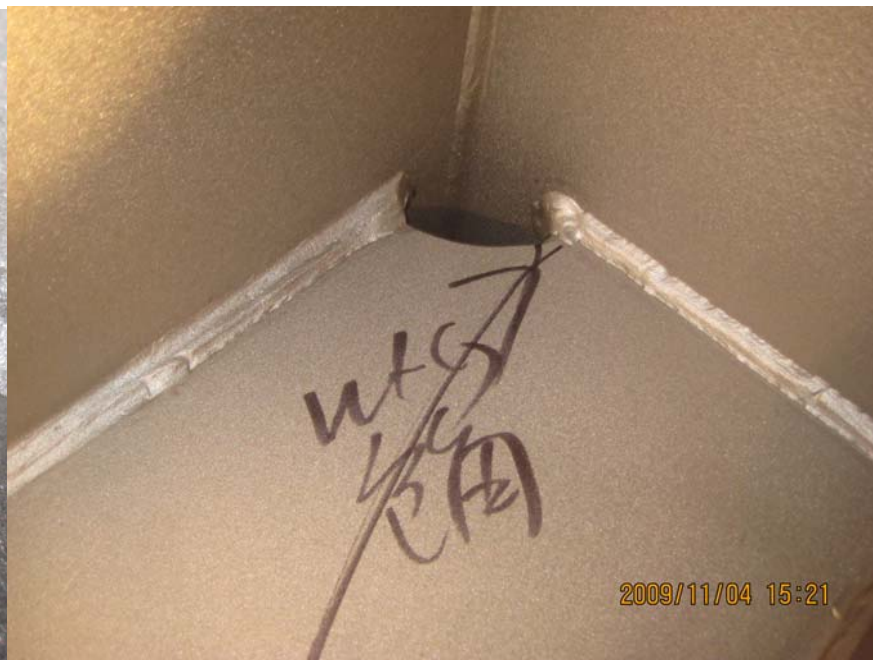
10: 包角电焊差 (---结构报检阶段清除)

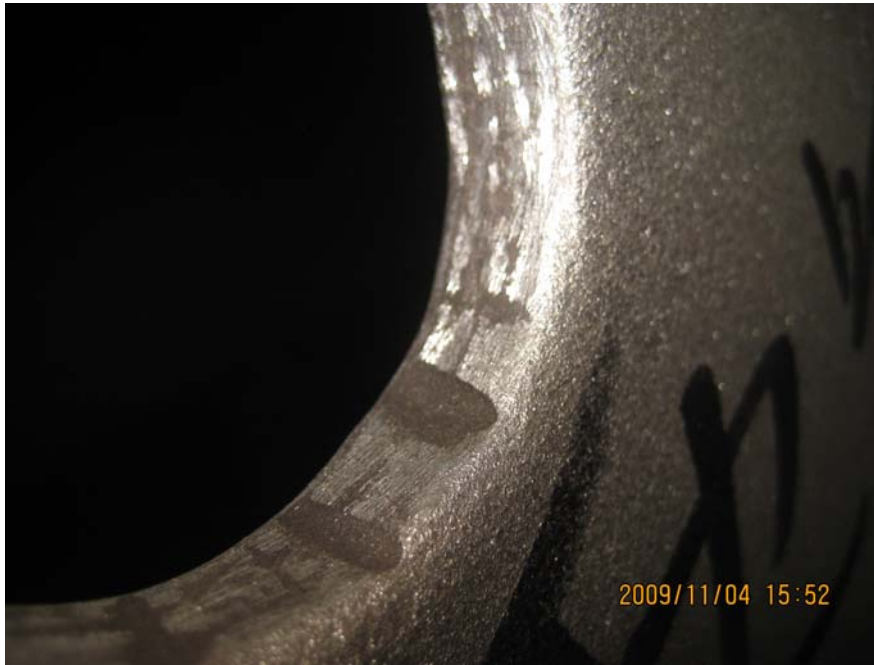
11: 复板下边口焊缝差 (---结构报检阶段清除)

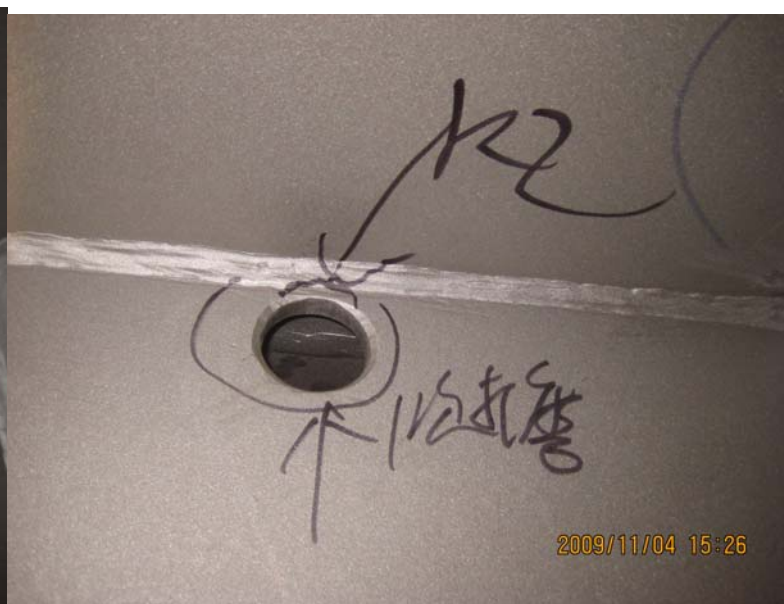
13: 复板自由边 R2 差 (---结构报检阶段清除)
